Access Compliance Report

Public Rights-of-Way

(Curb Ramps)

Intersection ID: 4004	Main Street: DOWNING_CREEK_DR	Cross Street: POINTVIEW_PL	Location: E
ADA ID: 2FFEAF3057BB	Ramp Type: BlendTrans1	Initial Pass/Fail: Fail	Overall Compliance: No
			Severity Score: 21.25

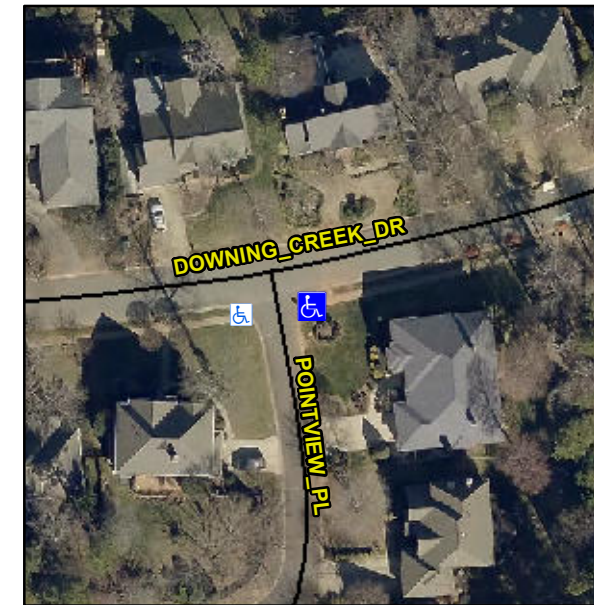
Not Found, R304.5.1, R304.5.3

Compliance	Description	Data	Compliance	Description	Data
N/A	Ramp Length (in)	190.0	Yes	BlendTrans Slope (%)	3.3
No	Ramp Width (in)	43.0	No	BlendTrans XSlope (%)	6.9
N/A	Flare Type LT	N/A	N/A	Flare Type RT	N/A
N/A	Flare Slope LT (%)	N/A	N/A	Flare Slope RT (%)	N/A
N/A	Flare Traversable LT?	N/A	N/A	Flare Traversable RT?	N/A
N/A	Landing Length (in)	N/A	N/A	DWS Provided?	N/A
N/A	Landing Width (in)	N/A	N/A	DWS Contrast?	N/A
N/A	Landing Slope (%)	N/A	N/A	DWS Length (in)	N/A
N/A	Landing X Slope (%)	N/A	N/A	DWS Full Width?	N/A
N/A	Landing Curb? (Y/N)	N/A	N/A	DWS Offset (in)	N/A
N/A	Shared Landing?	N/A			
N/A	Gutter Ponding?	N/A	N/A	Gutter Slope (%)	N/A
N/A	Gutter Lip Ht (in)	N/A	N/A	Gutter X Slope (%)	N/A
N/A	Painted X Walk1?	No	N/A	Painted X Walk2?	N/A
	X Walk 1 Direction	To SW		X Walk 2 Direction	N/A
	X Walk 1 Width (in)	N/A		X Walk 2 Width (in)	N/A
	X Walk 1 Slope (%)	4.1		X Walk 2 Slope (%)	N/A
	X Walk 1 X Slope (%)	6.4		X Walk 2 X Slope (%)	N/A

N/A	Ramp inside XWalk1?	N/A	N/A	Ramp inside XWalk2?	N/A
	Road Slope (%)	6.4		Clear Space?	N/A
	Road X Slope (%)	4.1	N/A	Clear Space to XWalk (in)	N/A
N/A	Any Obstructions?	N/A	N/A	Storm Grate/Utility Hazard?	N/A
	Obstruction Type			Storm Grate/Utility Type	
		N/A			N/A
			Yes	Surface Condition? (G/P)	Good
			No	Curb Slope (%)	17.1

Remove & Replace Curb Ramp With Two New Directional Ramps or Equivalent.
